Construction Division
Additions & Alteration Charges Approval Form

Company Name:	Modi Properties Pvt Ltd	Site	May Flower Platinum
Name of the customer	T. Sita Lakshmi		
Villa/ Flat No.	A-301

Details of Additions & Alterations

Flat No	301	Block no.	'A'
Flat Area	1500 sft	Type	Deluxe / Luxury
Buyer Name	T Sita Lakshmi		
Phone No.	8341068330/9866563164	Email	Sureshtadinada73@gmail.com

A-301
Elect

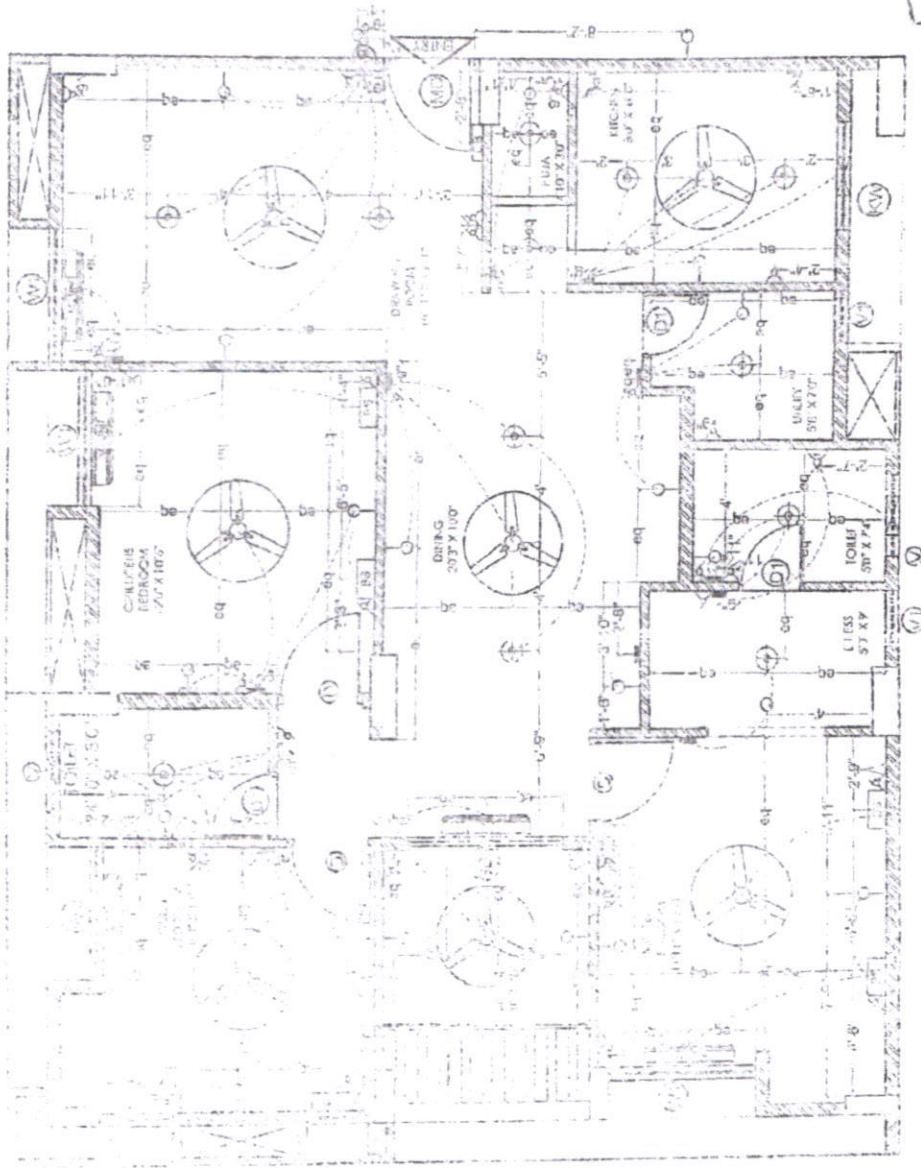
NOTE: 2'-0" FFL Bed ~~oxide~~ level marking not provided at internal walls flat.

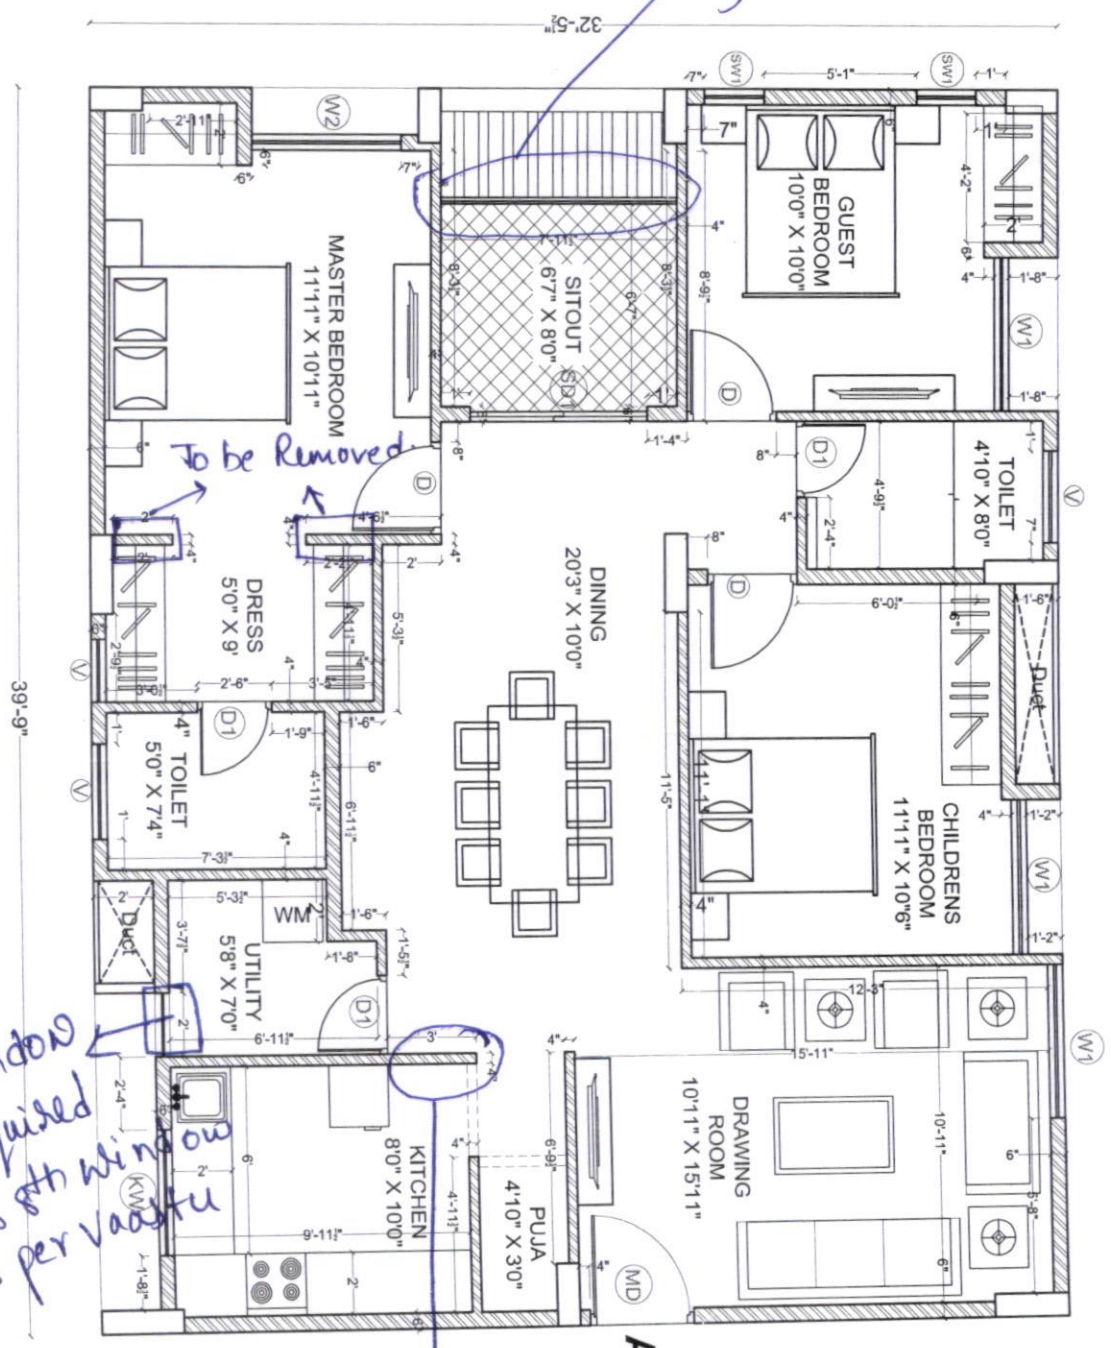
- Wall opening Required B/w Dining Area & Kitchen as Marked Per plan.

- Removal of Dress Area wall opening Required as Marked in plan. ✓

- French Window x 4-Track with Mesh Window. ✓

- Plain ceiling in All-Bedrooms & designed ceiling as in Hall & Dining Area as per model flat A-105. as discussed with Mr Azees.

- ~~Add light in the dining area.~~
Dining, Drawing Hall (20'x10'), Ceiling lights (5+5) Req
Window in the wash Area to be arranged as 8' window. as per ~~varity~~

Replace with
Stainless Steel with Glass
Partition

To be Removed

Window
Required
as per window
as per Vaastu

A1
3 x 2 1/2 feet
opening

ELECTRICAL PLAN OF FLAT-A1

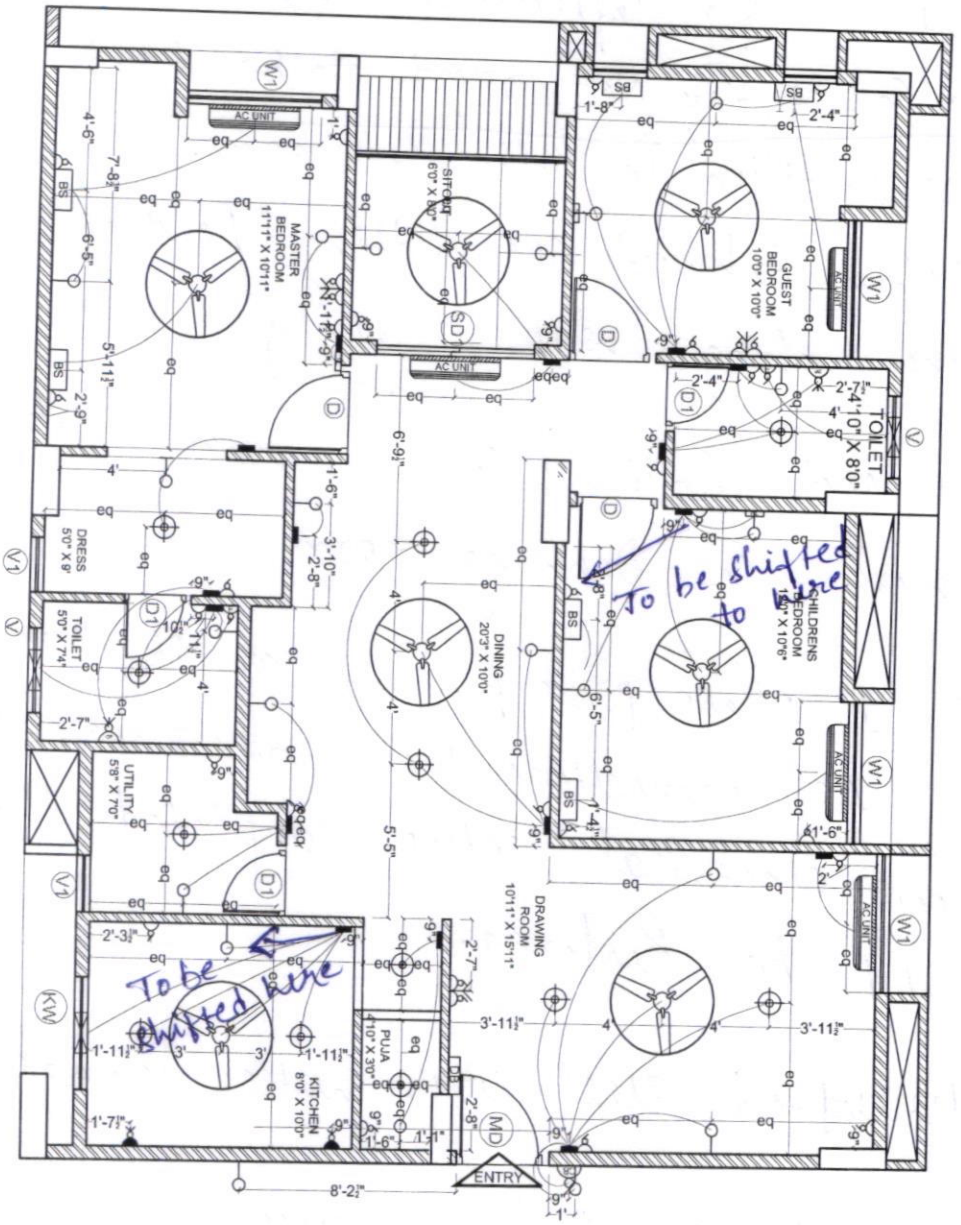
Children Bedroom 8-Way board to be shifted
Marked on plan.

- Switched Board in kitchen to be shifted
toward South Side of West wall.

PLUMBING PLAN OF A1

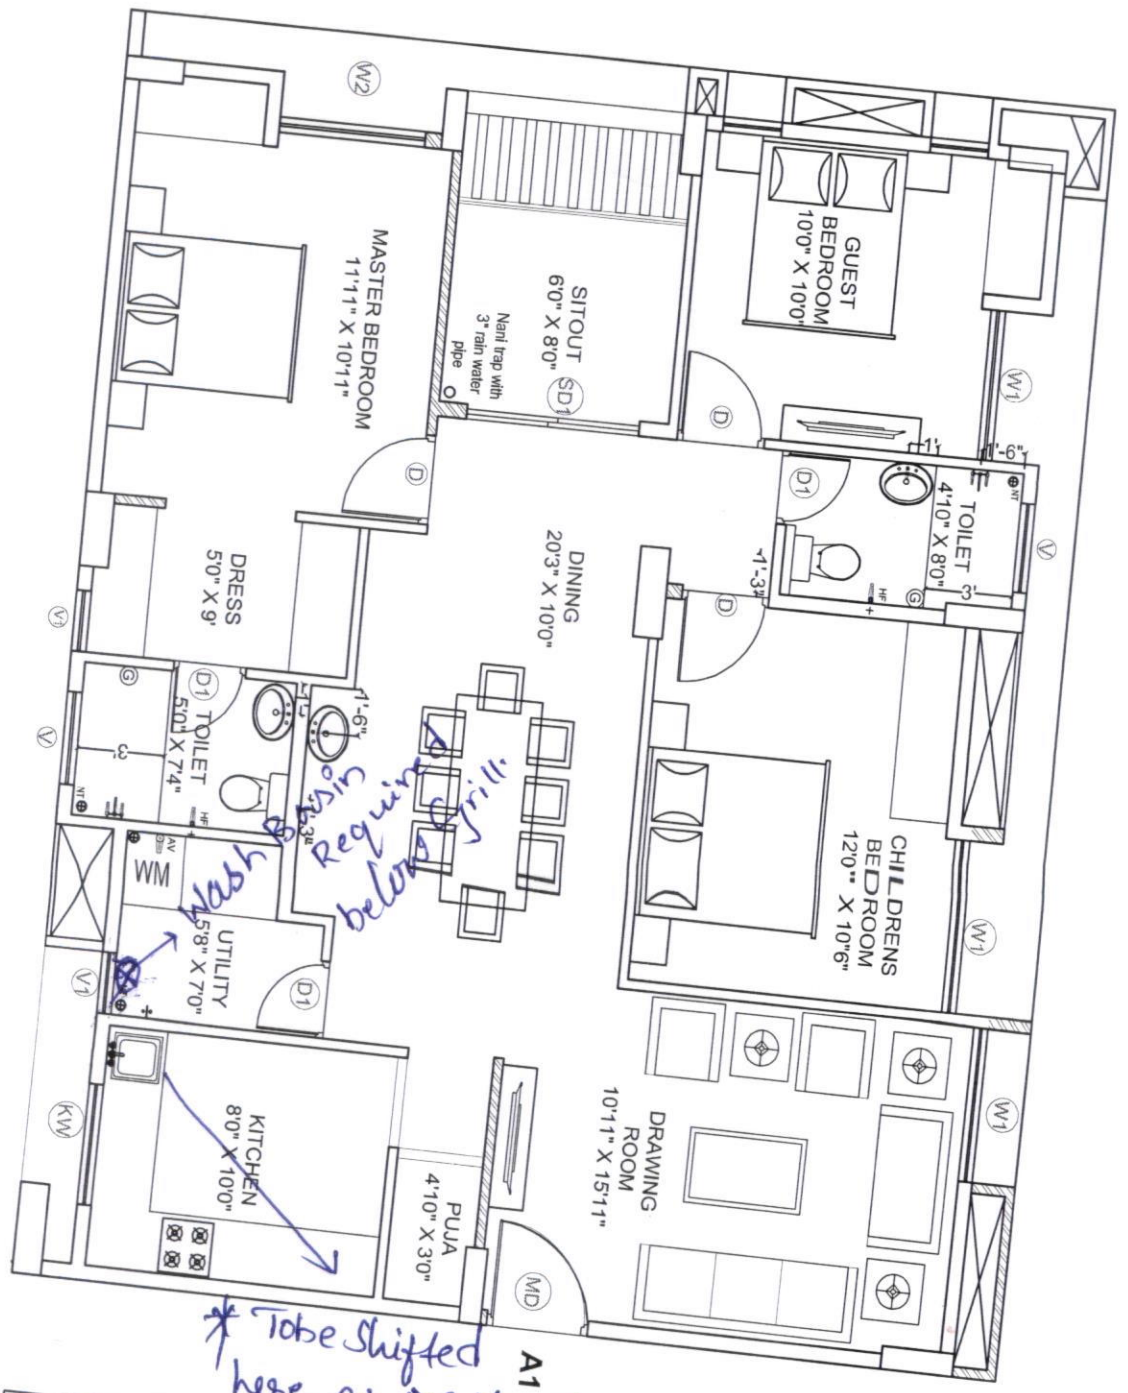
⊖ Wash Basin Required at utility Area South
Side wall below Grill. Marked on
plan. ~~marked from common area~~ ^(extra sink) ^{on}

⊖ Sink to be shifted/placed at North-East (N-E) Corner.

*Wash Basin
Requires
below grill*

** To be shifted
here as per Vaastu*
